# Service Bulletin

20-026

## Safety Recall: 2019 RDX Fuel Pump Motor

Supersedes A20-026, dated May 29,2020, to revise the information highlighted in yellow

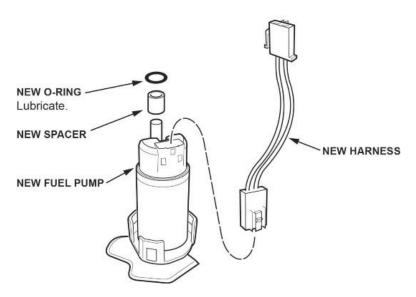
- Under PARTS INFORMATION, additional text was added.
- Under REPAIR PROCEDURE step 16, the NOTES and substep 16.2 were revised.

- 16. Assemble the fuel tank unit.
  - 16.1. Install the new spacer, O-ring, and wire harness to the new fuel pump.

- The O-ring must be installed on the pump as shown, not on the fuel filter side.
- · Coat the O-ring with clean engine oil; do not use any other oil or fluid.
- Do not pinch the O-ring during installation.
- When connecting the wire harness, make sure the connection is secure and the connectors are firmly locked into place.
- Use all the new parts supplied in each replacement kit.

16.2. Place the fuel pump on a bench, then install the filter to the fuel pump.
